Gulf Coast Consulting, Inc.

March 13, 2026

Re: 375 Turner Street – DRC Action Agenda
Case No.: FLD2025-10026
Atlas Page: 295B
Zoning District: I - Institutional
Address: 375 Turner St, Clearwater FL 33756

Pursuant to your request for additional information correspondence received on March 2, 2026, the following are our responses to each of the review comments:

LANDSCAPE PLAN
 Project No. 24-01
 Date 01/30/24
 Sheet LA1

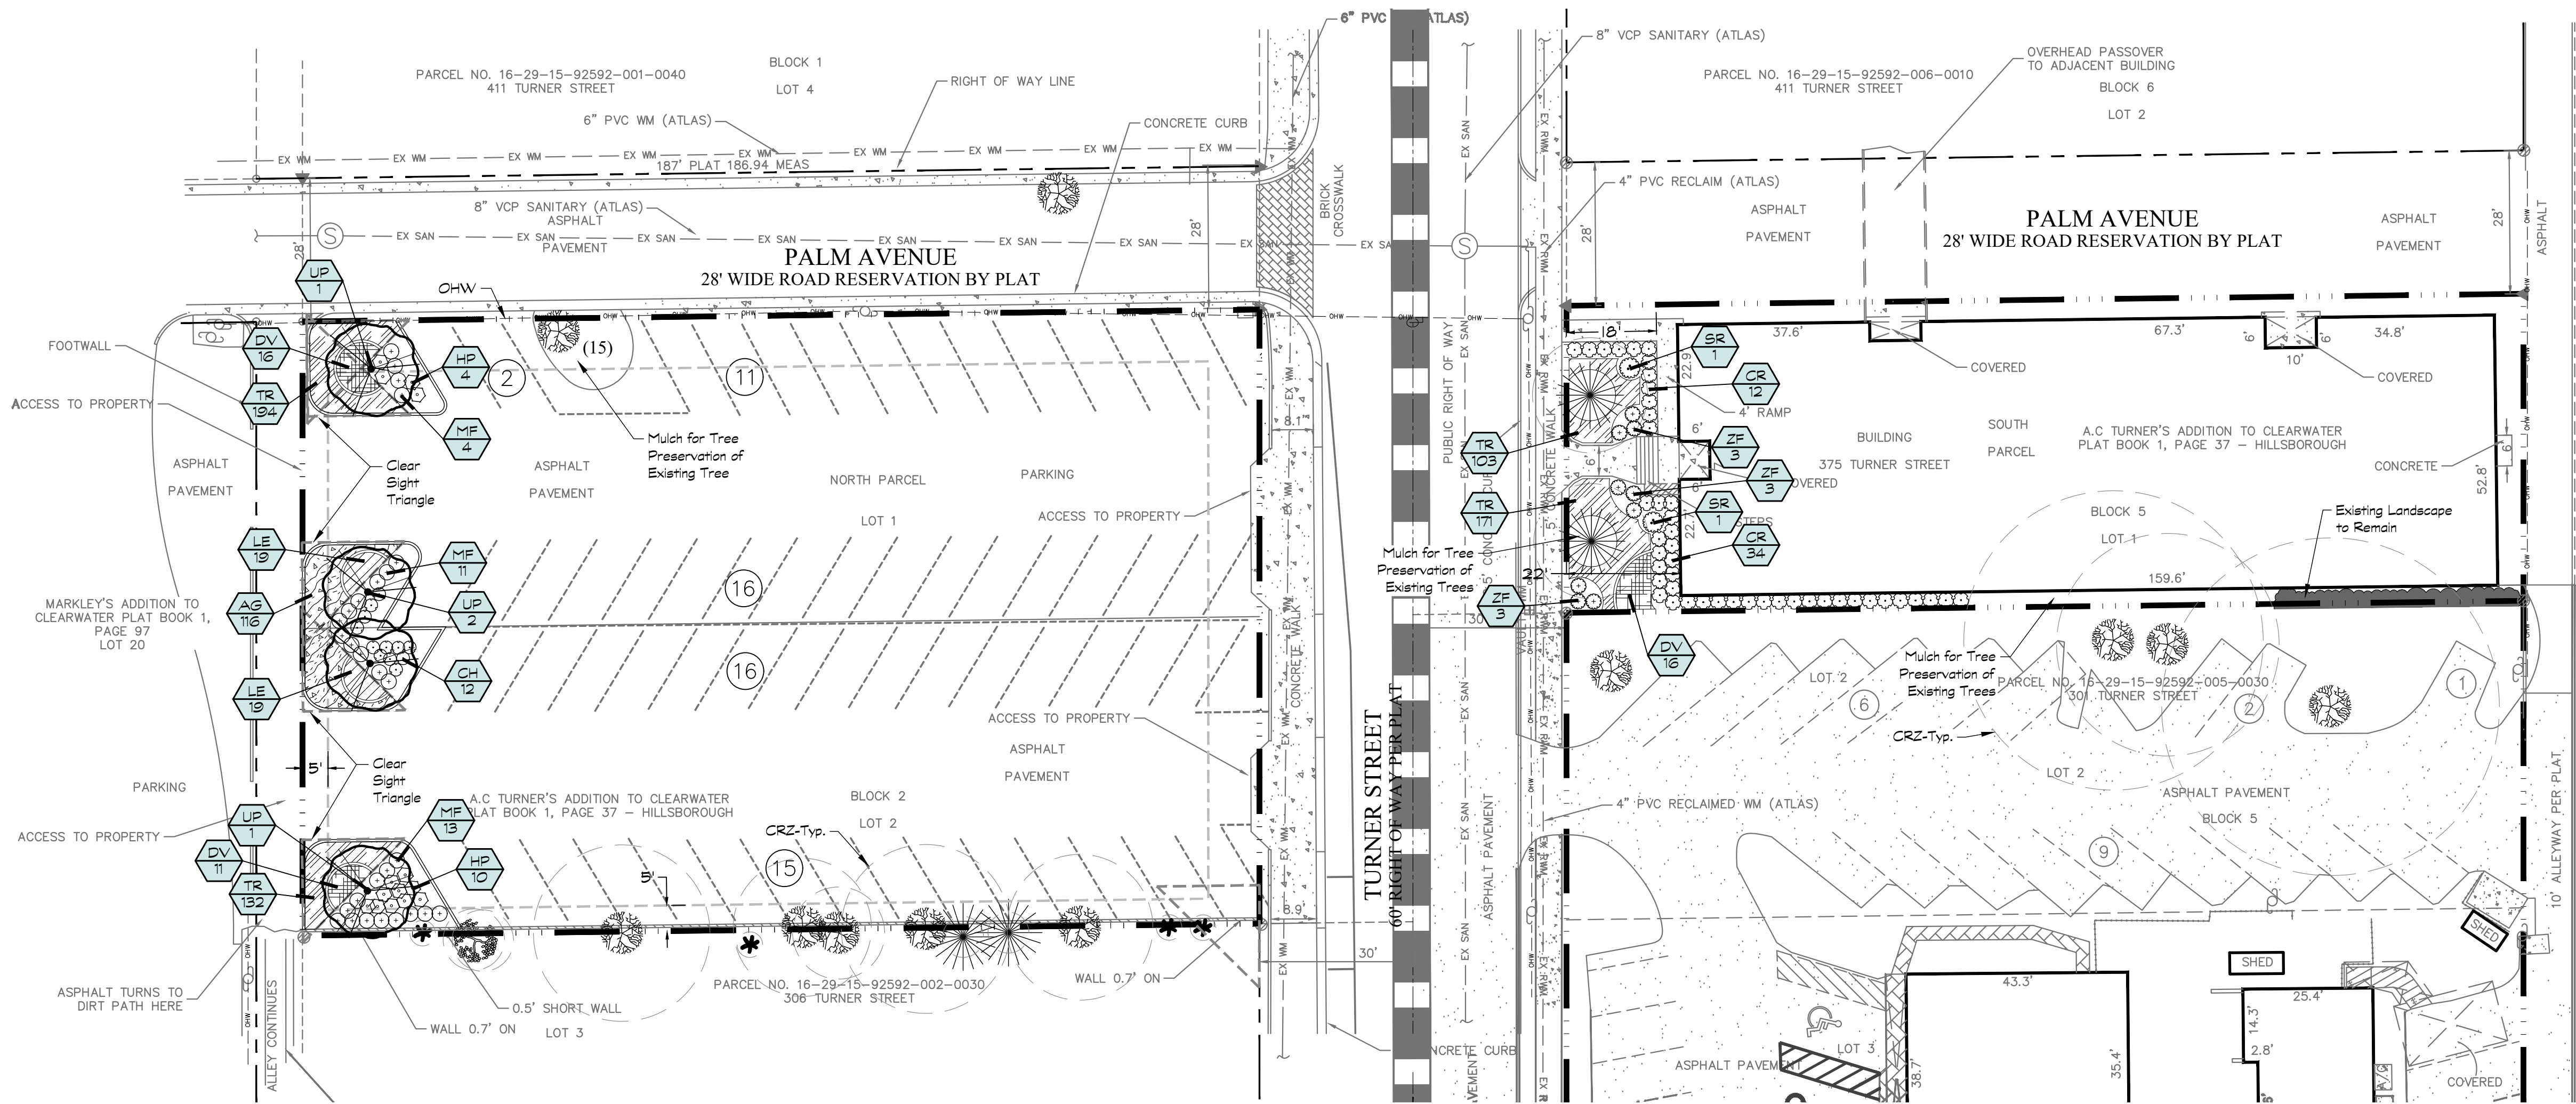
1. Tree #15 is slated to be removed in the tree table but is not shown to be removed on the plan and is still shown on the landscape plan. Please revise.

1. Plan updated to show tree #15 being removed.
